The changes permit operation of Peach Bottom Unit No. 2 with a new type reload fuel (8x8R) for Cycle 4.

PEACH BOTTOM ATOMIC POWER STATION, UNIT NO. 2

AMENDMENT TO FACILITY OPERATING LICENSE

Amendment No. 48
License No. DPR-44

Figure 3.5.1.G Maximum Average Planar Linear Heat Generation Rate Versus Planar Average Exposure

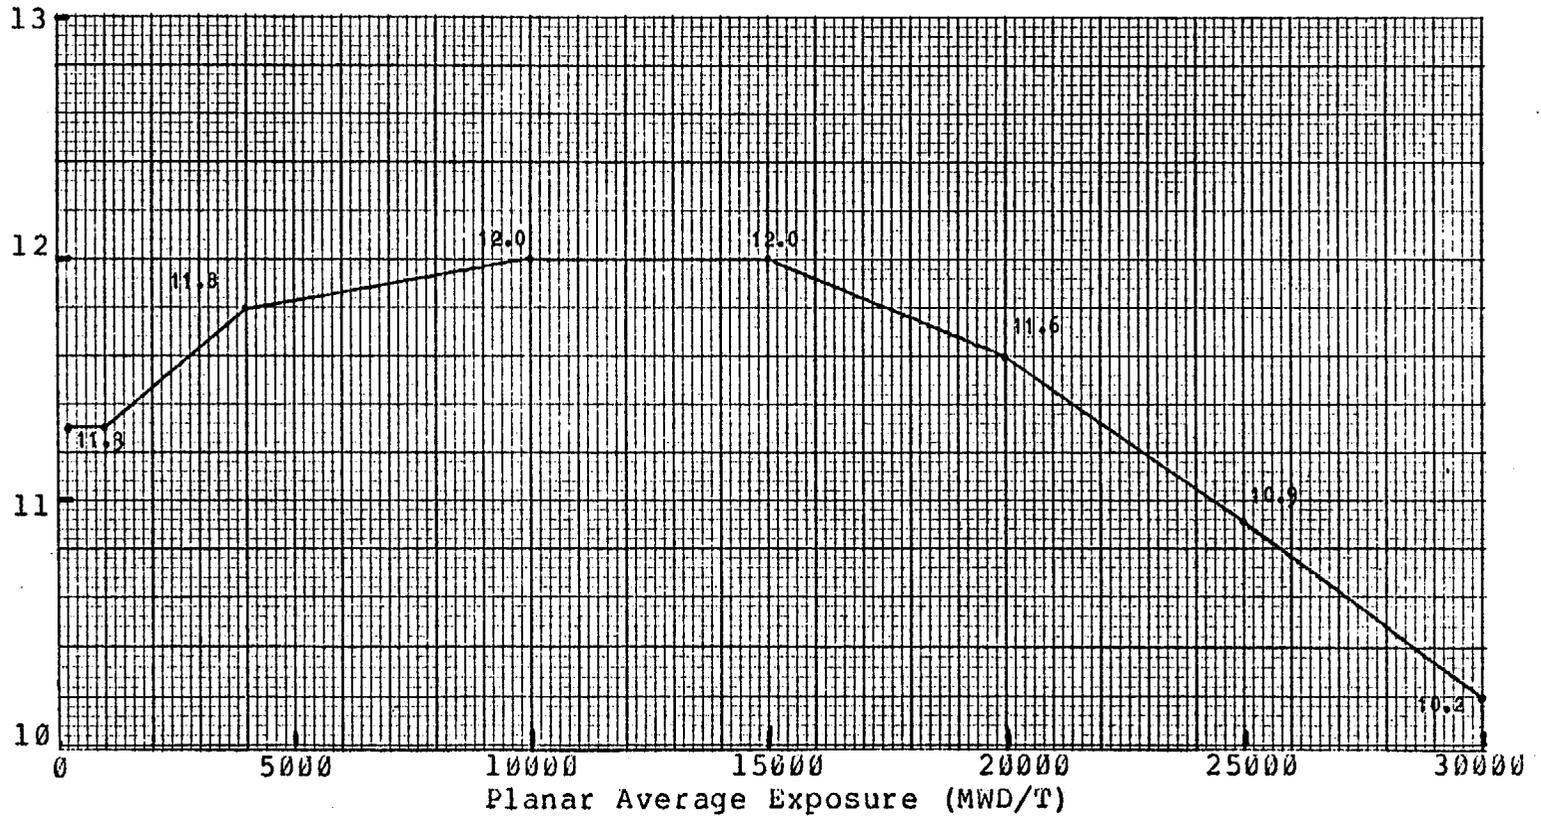
The proposed technical specification changes⁽¹⁾ include a revised fuel cladding integrity safety limit MCPR, a revised exposure-dependent operating limit minimum critical power ratios (MCPR) for each fuel type, addition of a MAPLHGR vs average planar exposure curve and addition of a design maximum total peaking factor for the reload 8x8R fuel assemblies.

The proposed 8x8R design maximum total peaking factor of 2.51, used in connection with the APRM Flux Scram and APRM Rod Block Trip Settings has been reviewed and found to be acceptable. Finally, we find that the proposed MAPLHGR vs average planar exposure curve is adequate to assure conformance with the requirements of 10 CFR 50.46 and Appendix K to 10 CFR 50.46 for the reload 8x8R fuel assemblies.

During power operation, the APLHGR for each type of fuel as a function of average planar exposure shall not exceed the limiting value shown in Figure 3.5.1.A, B, C, D, F, & G, as applicable. If at any time during operation it is determined by normal surveillance that the limiting value of APLHGR is being exceeded, action shall be initiated within one (1) hour to restore APLHGR to within prescribed limits. If the APLHGR is not returned to within prescribed limits within five (5) hours reactor power shall be decreased at a rate which would bring the reactor to the cold shutdown condition within 36 hours unless APLHGR is returned to within limits during this period. Surveillance and corresponding action shall continue until reactor operation is within the prescribed limits.
